Honeywell  
101 Columbia Rd  
Morristown, NJ 07962

Re: PRP's Response to EPA's Letter Dated January 3, 2013  
Final Comments on November 2012 Draft of the Remedial Investigation for  
Operable Unit 3-Upland Soils: LCP Chemical Company NPL Site, Brunswick,  
Glynn County, Georgia

## **Attachment 1**

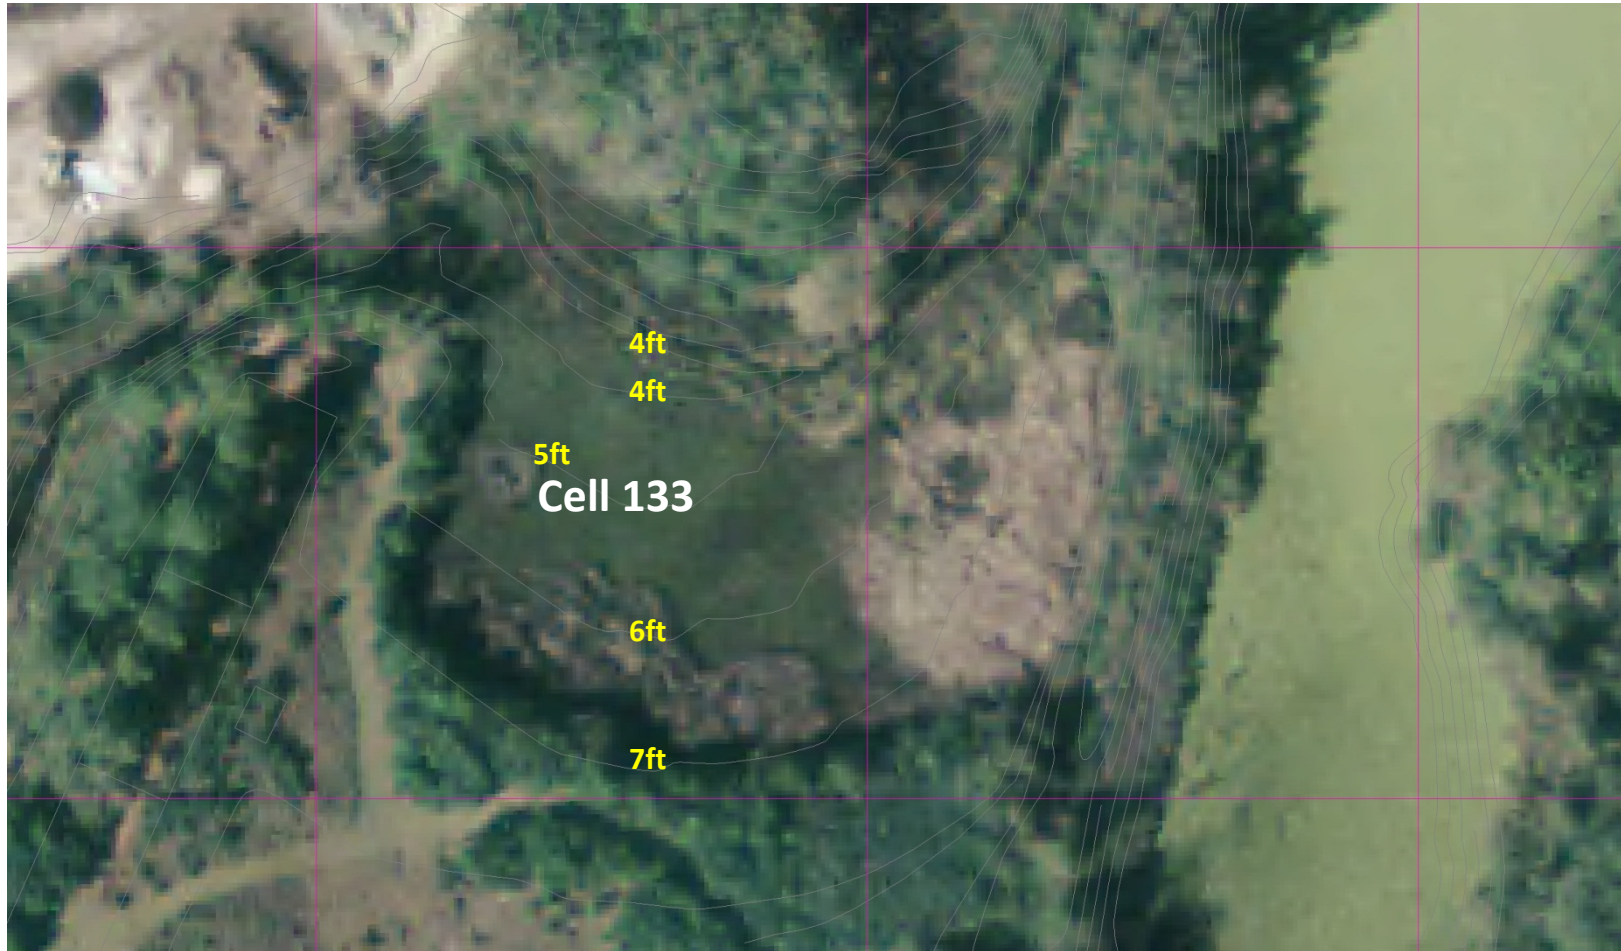
1) *The removal areas shown on the figures obstruct the view of the grids. Please fade-out the removal area color so that the grids may be seen.*

The grid line "layer" will overlay the removal areas in the GIS (used to create the figures), to show the full outline of the grid boundaries as requested. Attachment 1 provides an example of how the figures will be edited.

## **Attachment 2**

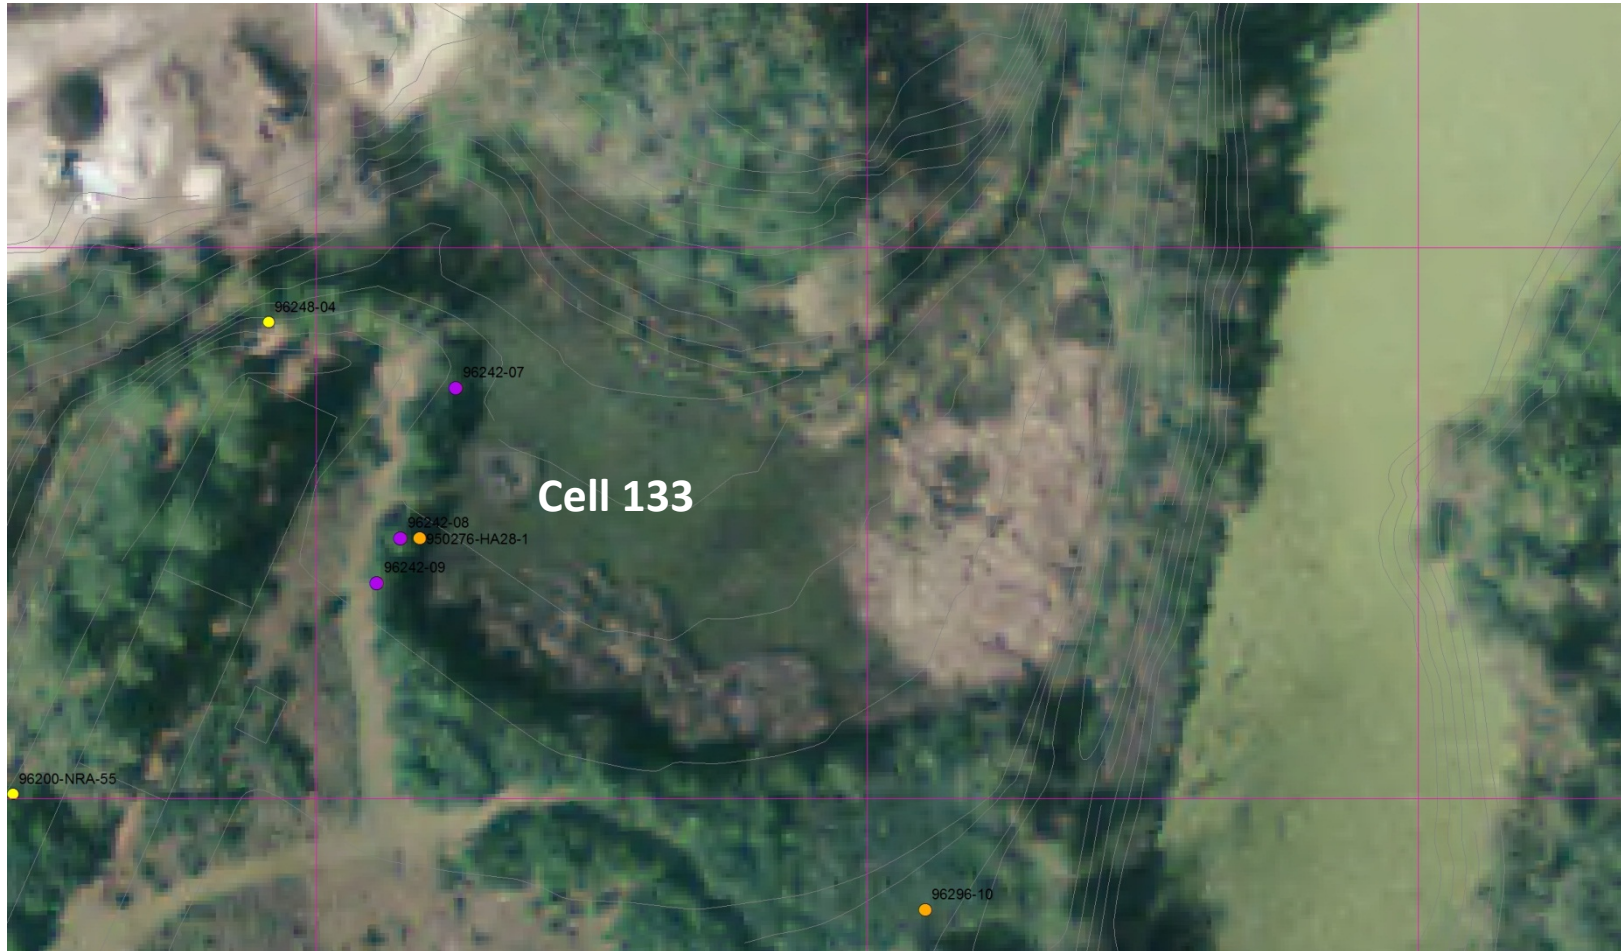
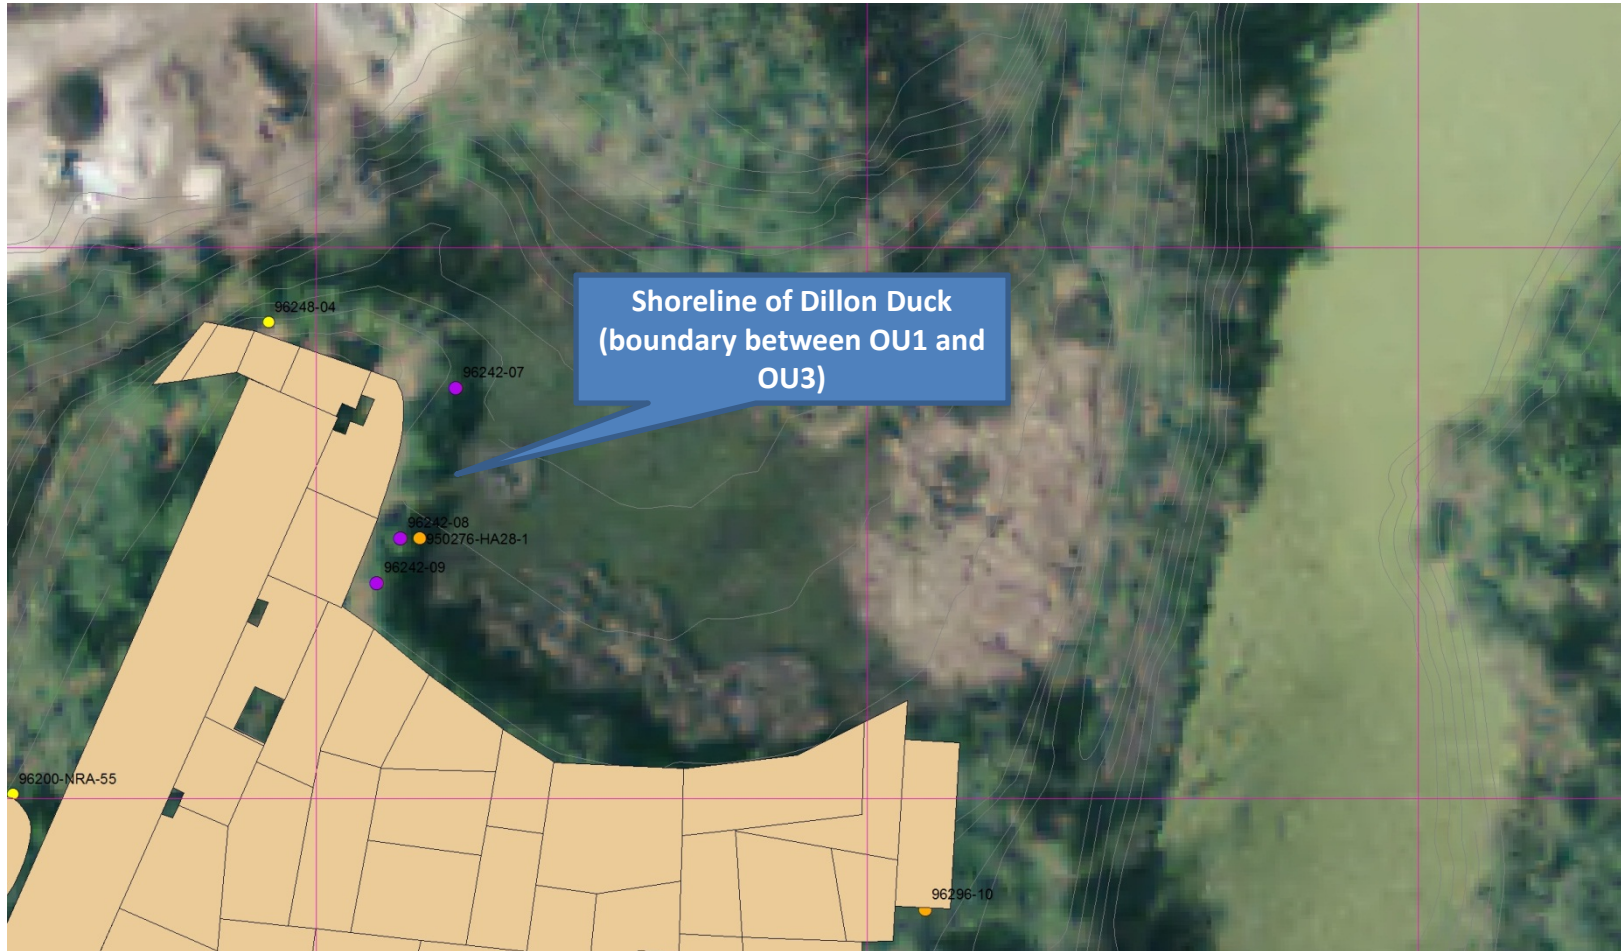
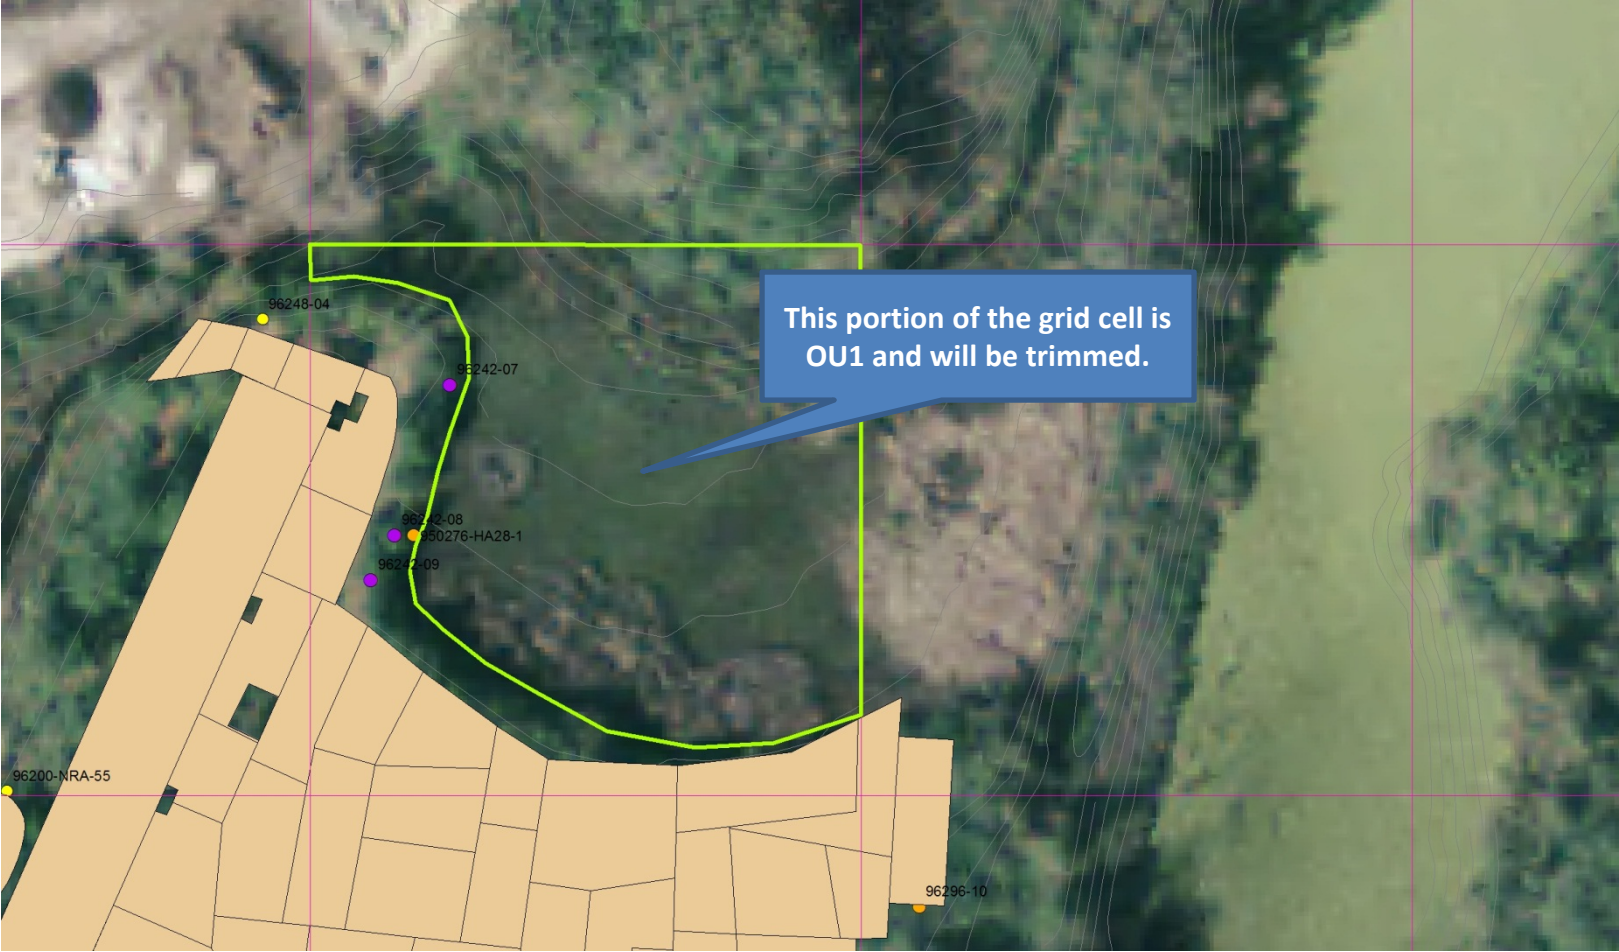
2) *Page C-4 of the Appendix C discusses the distribution of lead in surface soils of OU3. The uplands were gridded out, and average concentration within the grids were plotted on the figures. The text does not mention that the concentration of the lead in soils are above the 400 mg/kg preliminary remediation goal (PRG) for the mourning dove in Grid 133 when the one sample from TEG is eliminated. The three non-TEG sampled have lead concentrations of 922, 1580, and 832 mg/kg. Grid Cell 133 is located adjacent to the southern portion of the Dillon Duck and is in a habitat area. Soils in the shore of the Dillon Duck could erode into the pond. Waterfowl accessing the pond from the shores could come into contact with elevated lead in soils and become exposed through incidental ingestion of soils. Lead concentrations in soils are relatively low apart from within Grid Cell 133. The text should mention that the highest average concentration of lead in soils is located in a habitat area.*

*Note that the figure in the December 1997 North Area Close-Out Report showing the removed characterization / confirmational sampling locations, does not show the three samples located in in Grid Cell 113 referred to above. The characterization samples table in the report does list the three samples. The field notes on the August 30, 1996 chain-of-*

*custody form describes the three samples as having been collected along the “edge of marsh along east site of N(orth) S(eparator).” Further, the as constructed excavation figure included in the Close-Out Report (reproduced in part below) shows the area immediately east of the North Separator having been removed and backfilled. It is unclear whether the area represented by these three samples was removed. This required further investigation.*

Grid cell 133 is occupied mostly by the “Dillon Duck”, a saltmarsh area that is part of OU1 and is not upland soil. The soil samples used in the averaging exercise in this grid (four locations) were not excavated during the uplands removal action. They occur in the narrow strip of unexcavated upland along the bank. Note that concrete rip-rap was placed along this bank as part of the removal action to stabilize the bank from sloughing with the excavation that was performed along the top area. Photographs of the rip-rap are provided in Attachment 2 to this Response to Comments document. There is no indication that this bank is eroding into the Dillon Duck as suggested in the first part of the comment. Furthermore it would be inappropriate to describe the broader portion of Cell 133 as “habitat” as requested in the comment, in the sense that this is not OU3. It would be appropriate to trim this cell to the shoreline border between the uplands and the saltmarsh (as has been done along the western margin of the gridded area along the site). Attachment 2 provides a sequence of figures that illustrate the site setting and features of this area, in support of the response to comment offered.
